## VENDOR SERVICE PUBLICATION

**SUBJECT:** CONTINENTAL MOTORS CRITICAL SERVICE BULLETIN CSB19-01,  
'FUEL (PRIMER) DIVERTER VALVE ASSEMBLY'

**CATEGORY 2  
CSB19-01**

**SUBJECT:** Fuel (Primer) Diverter Valve Assembly

Figure 1. Fuel Diverter Valve Assembly, typical

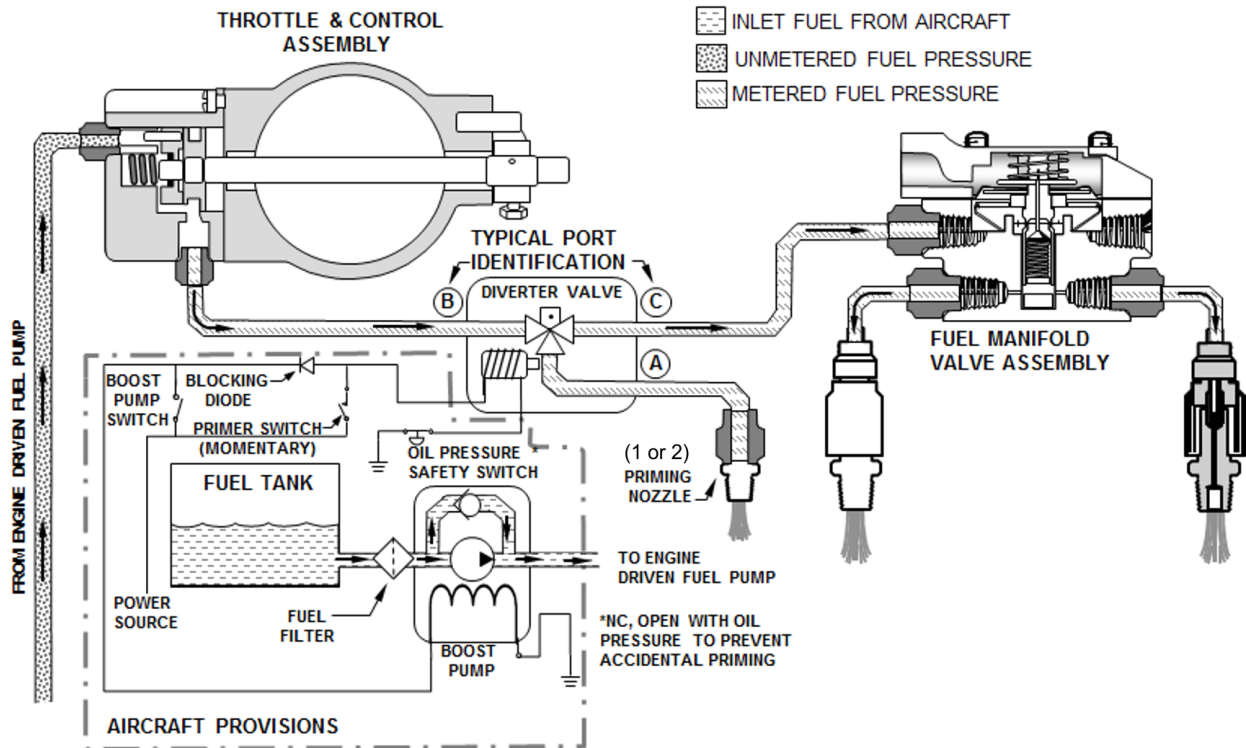
1. Verify your cross-flow engine has a fuel diverter valve assembly (P/N 633862-1, 642199-1, (14V), or 633862-2, 649268-2 (28V), as shown in Figure 1).

- a. Remove fuel diverter valve assembly (tubes and connectors) between the throttle and control assembly and fuel manifold valve assembly (see Figure 1, port identification B & C and Figure 2 through Figure 4, example configurations).
- b. Remove tube/hose assembly, as applicable, (see Figure 1, port identification A and Figure 2) between fuel diverter valve assembly and priming nozzle(s).
- c. Remove disconnected priming nozzle connector(s) and tube assemblies connected to induction system (location references see Figure 2 and Figure 7).

**Figure 5. Cylinder Drain Connector, P/N 632068 superseded by 655742**

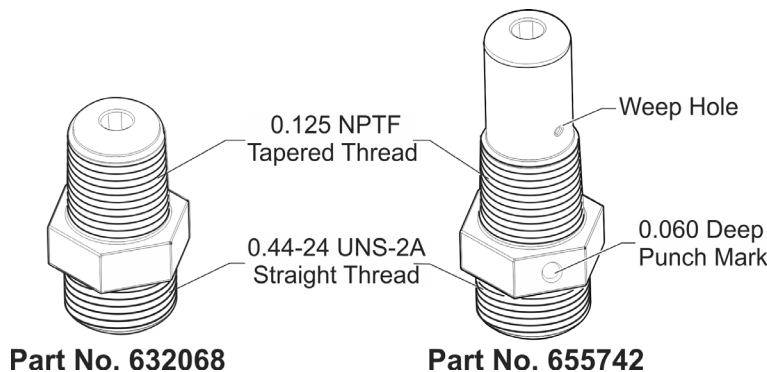
The cylinder drain connector serves the same priming function as the primer diverter valve and allows the removal of the fuel diverter valve assembly from current production model specifications. Inspect for the current production cylinder drain connector (P/N 655742). The cylinder drain can be identified by a 0.060 deep punch mark in the wrenching flat (see Figure 5, P/N 655742).

1. If the cylinder drain is identified as P/N 655742, replacement is not necessary.
2. If the cylinder drain cannot be identified, perform an “Induction System Drain Inspection” according to M-0, Standard Practice Maintenance Manual, Section 6. If applicable, remove and replace cylinder drain connector(s) with current P/N 655742 (quantity based on number of engine cylinders).

**Figure 6. Hose Installation, IO-360-ES; TSIO-360-MB, SB**

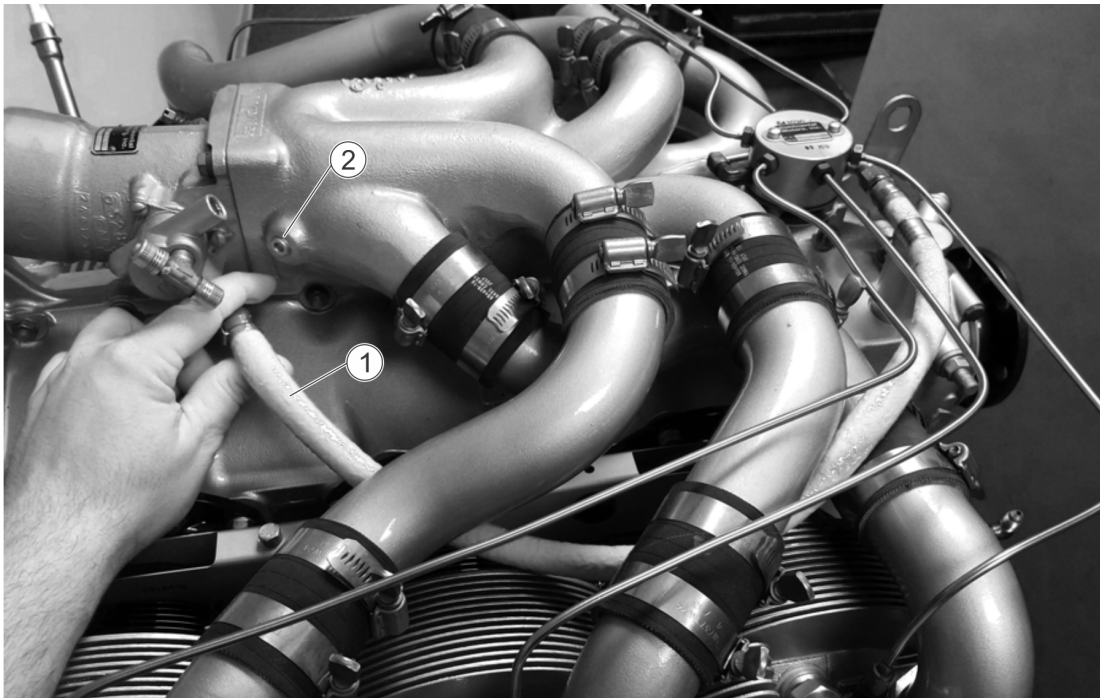
1. Install new hose/tube assembly (reference Table 2 through Table 5 and Figure 6 through Figure 9) between throttle body (mixture control outlet) and fuel manifold valve inlet fitting.
2. Lubricate the hose/tube connector threads with clean 50 weight aviation engine oil.
3. Torque tube or hose fittings to the values specified in the latest revision of M-0, "Standard Practice Maintenance Manual, Appendix B."
4. Install plug(s) (reference applicable parts list tables) to terminate induction tube port(s). Lubricate the plug threads with Loctite® 592 PST thread sealant and torque to the values specified in the latest revision of M-0, "Standard Practice Maintenance Manual, Appendix B."

**Figure 9. Hose and Clamp Assembly, TSIO-520-BE; TSIO-550-A, B, C6B, E**

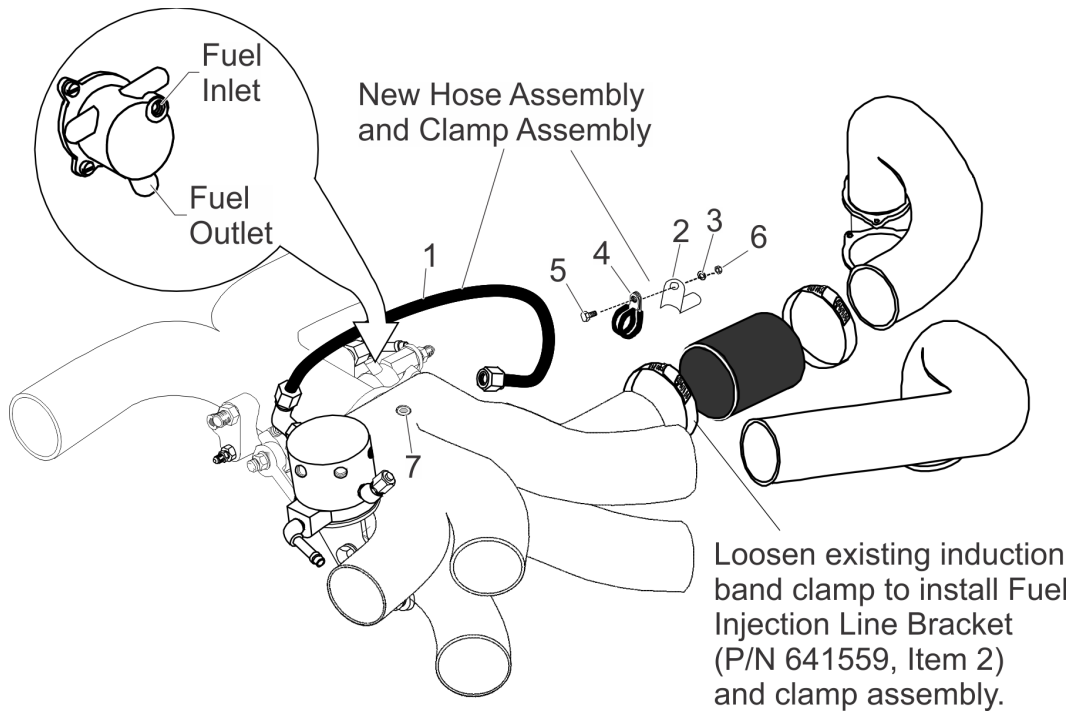
5. Reference Figure 9, to assemble the hose assembly (P/N 646644S6S23.00) and clamp assembly (fuel injection line bracket (item 2) for the TSIO-550-C6B engine. Loosen the induction clamp at the induction joint and insert bracket (item 2) under the induction clamp.
6. Reposition the induction clamp on the induction tube and torque to the values specified in the latest revision of M-0, “Standard Practice Maintenance Manual, Appendix B.”

NOTE: If the clamp will not tighten or remain torqued to Appendix B specifications, the clamp is unserviceable, replace the induction clamp and perform a service inspection according to M-0, 6-4 “*Induction System Inspection.*”
